CITY OF MORGANTON
NORTH CAROLINA

August 16, 2022

Addendum #1 for (Resurfacing Project for the City of Morganton 2022)

Spainhour St 35ft Rad 3:1 Slope
Scale: 1"=30'

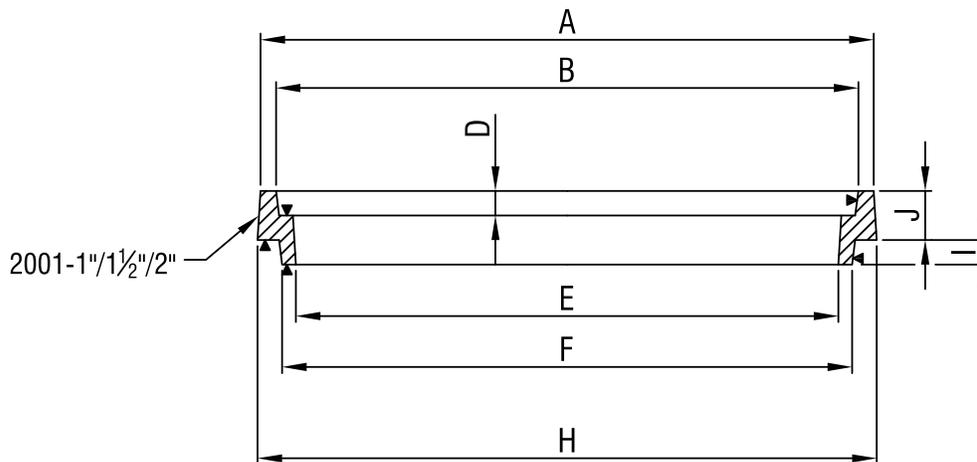
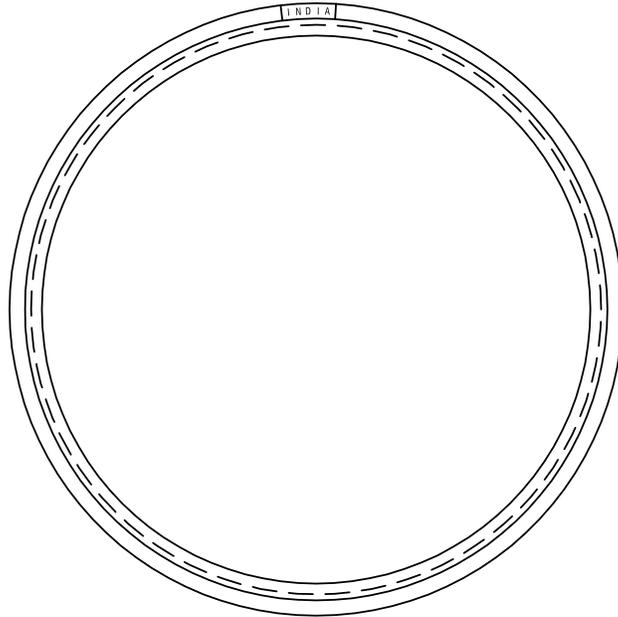
Please find the revised bid proposal for the (Resurfacing of Specified Areas at Morganton Waste Water Treatment Plant); with a line item added for the milling of areas to be resurfaced. Also please find a bid proposal and sketch map for a 35-foot cul de sac at the end of Spainhour St. (Spainhour Street Improvements). This would be Additive Alternate to the project and may or may not be included as part of the project. With this request a new bid deadline and bid due date will be 2:00 P.M. on Tuesday, August 23, 2022. Also please find the contractor questions and answers. If there are any questions on the (Spainhour Street Improvements), please submit to City Engineer by end of business day 5:00 PM on Thursday August 18th 2022.

1. Clearing and Grubbing – Bid price per square yard for clearing, grubbing and proper dispose of debris off site.
2. Grading and Fill Dirt - Bid price per square yard for grading, dirt fill and compaction of fill with sheep foot roller, and tie-in to existing pavement per plans, specifications and details. Contractor shall provide, haul and place all fill dirt for street improvements and 35’ Rad. Cul de sac with a 3 to 1 slope, 0.01 CY cut, 742 CY fill.

2001 MANHOLE RISER

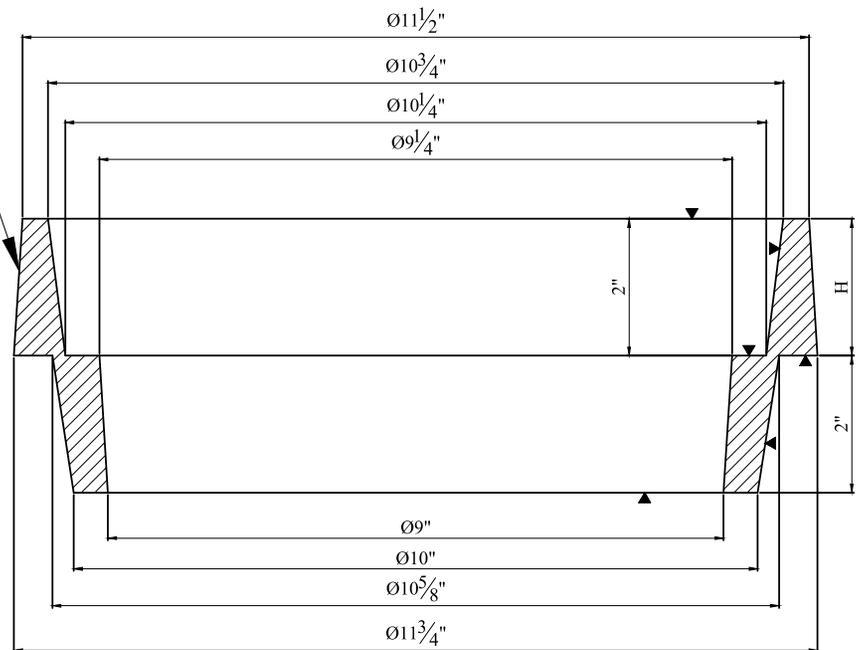
- 5- Will drop-in rings for manhole and water valve adjustment be allowed on streets only scheduled for resurfacing (no milling), provided an approved shop drawing submittal for each ring is in-place? [Yes, manhole risers and water valve risers shall be used on non-milled streets to match the new depth. See attached specification sheets.](#)
